AURA DEVELOPMENT – PRECINCT 15 (WEST)

Road Traffic Noise Assessment

Report
227401.0008.R04V05

Table 1.1: SARA Information Request (11 June 2024) and Summary Response

Figure
C.3

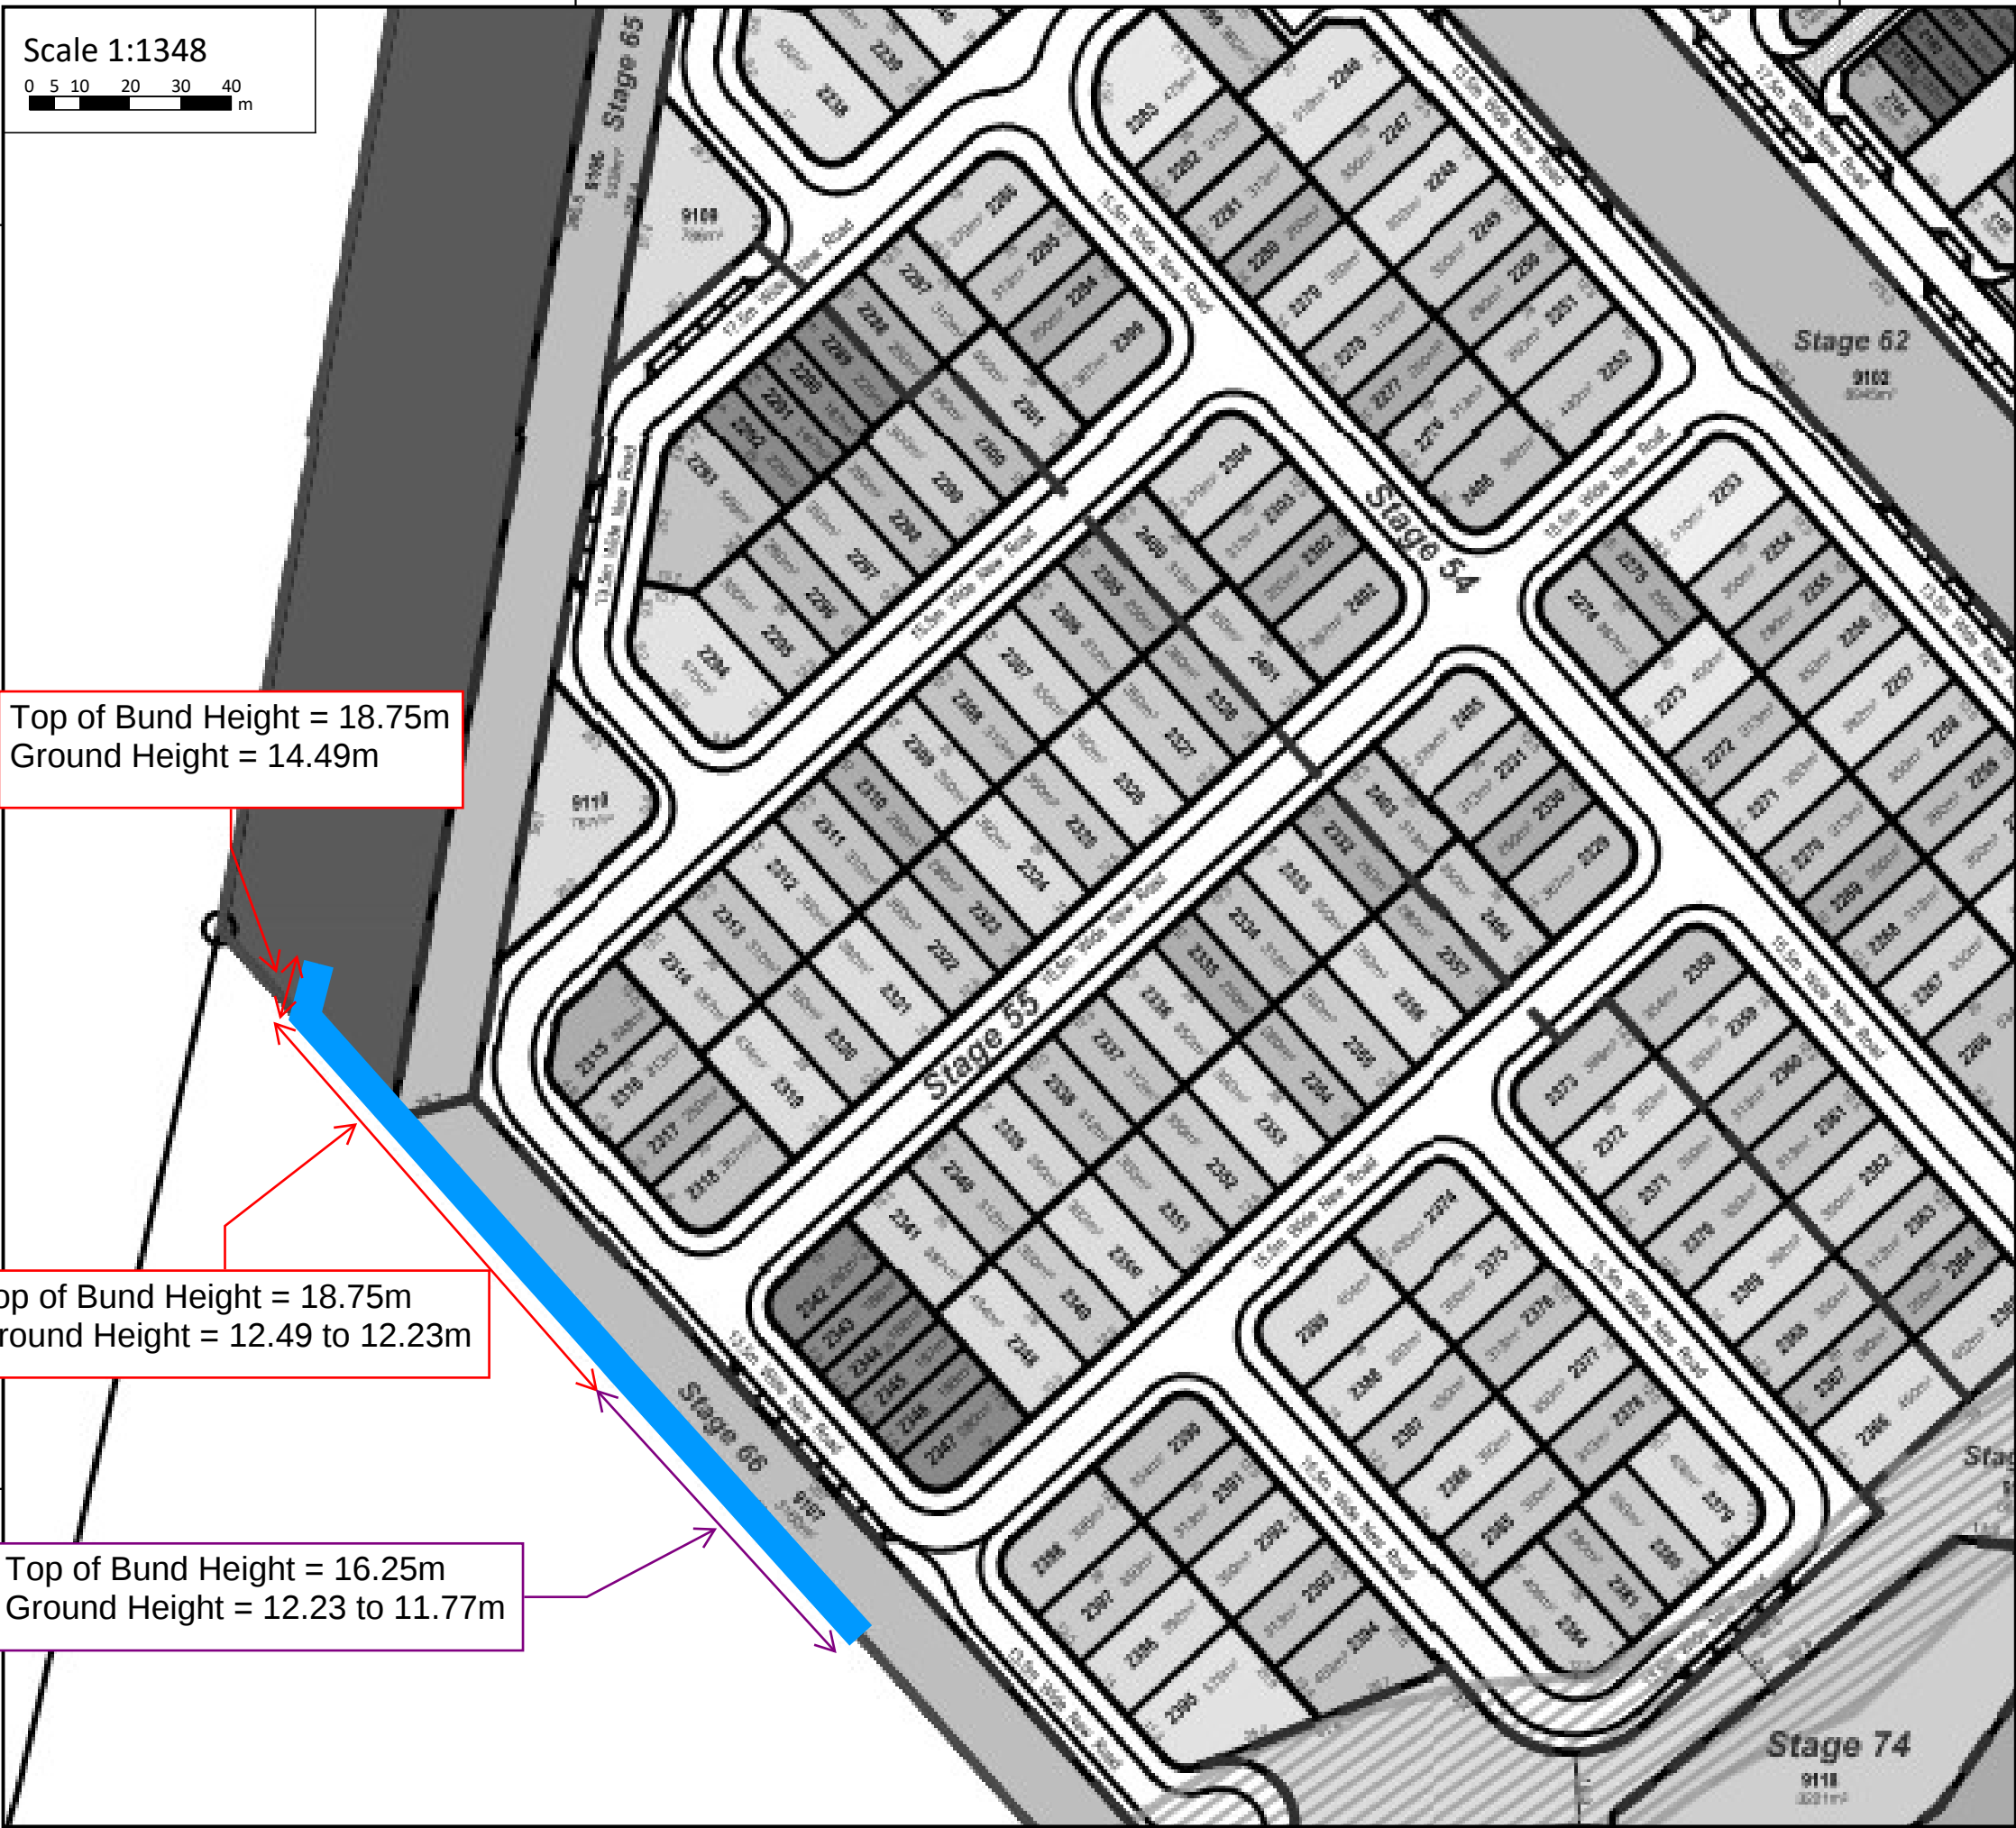
Item 1b Update Figure C.3 referencing the updated Egis drawings.	Figure C.3 provides a reference to the relevant Egis detailed design drawings.
Item 1c The noise report assumes a road surface of dense graded asphalt for the Bruce Highway. Based on information available the road surface is not dense graded asphalt and is open grade asphalt.	The noise modelling has been updated to consider open graded asphalt along the Bruce Highway.

Note: Barrier heights are relative to design heights in Egis Drawing 3058-DA021 and DA022, refer to Appendix G

Figure
C.7

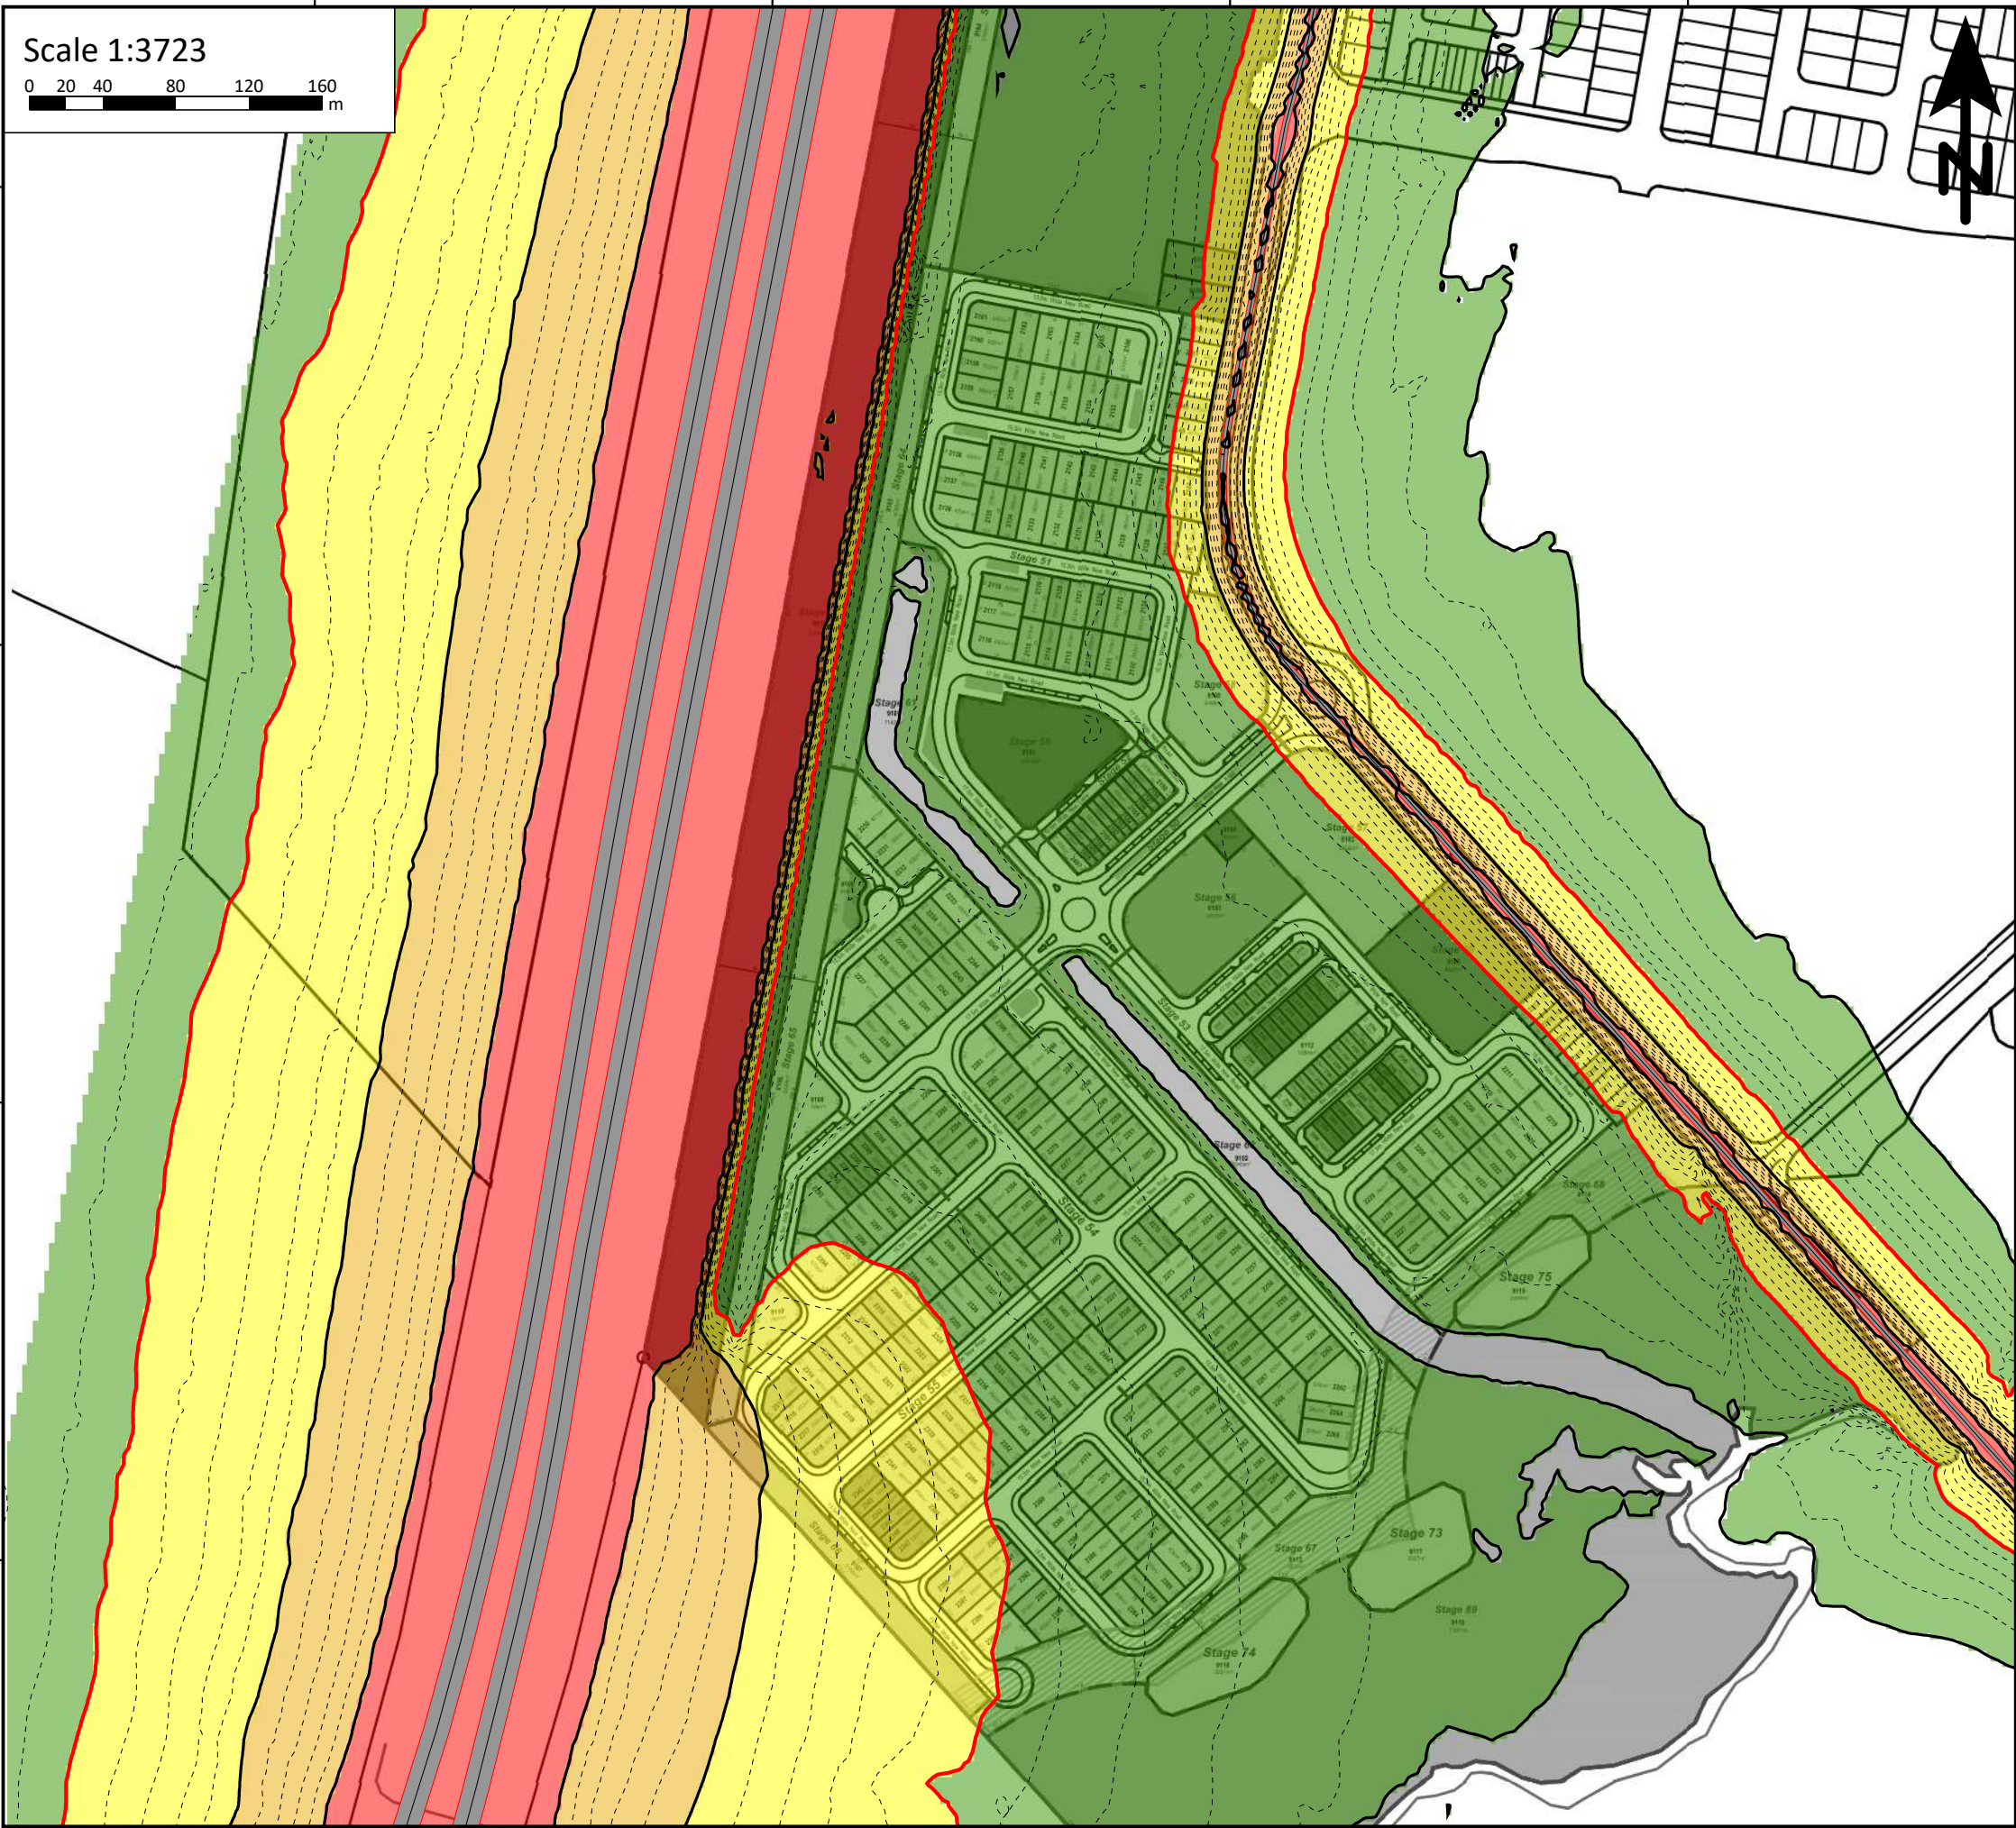
Item 1g Recommendations and Conclusions – This section states, "Full compliance with the SDAP limits at ground level is predicted (for noise generated by the Bruce Highway)." The proposed noise barriers do not achieve full compliance	Full compliance is predicted to be achieved with the 63 dBA façade limit at ground level and 60 dBA limit at private opens spaces, with the proposed barriers. Refer to Figure C4 and Figure C7. Figure C7 shows the predicted free-field noise levels for comparison to the 60 dBA private open space limit. The front portion of lots of 2395 to 2397 exceed this limit (by 1 dBA), however, it is noted, that the rear of the lots,

Information Request Item	Summary Response
with SDAP limits. The conclusions should include an assessment against all SDAP requirements, including assessment against the 60 dB(A) free field noise criteria.	where private open spaces would be fully shielded and the noise model is over-predicting by + 3.8 dBA. Given this, compliance is considered to be achieved.

Predicted noise level contours for outdoor areas are provided in **Figure C.7** in **Appendix C**. While outdoor noise limit exceedances are noted for lots 2395-2398 by up to 1 dBA, the following points are noted:

- Private open space (for which the 60 dBA limit applies) would be located in the rear of the lots. The houses in these lots will provide shielding from noise to any rear private open space, reducing noise levels even further.
- As discussed earlier, the model is over-predicting by +3.8 dBA (when comparing predicted and measured noise levels for the monitoring completed in June 2024, refer to **Appendix E**). Even adjusting the results down to a conservative +2.8 dBA model accuracy would result in full compliance.
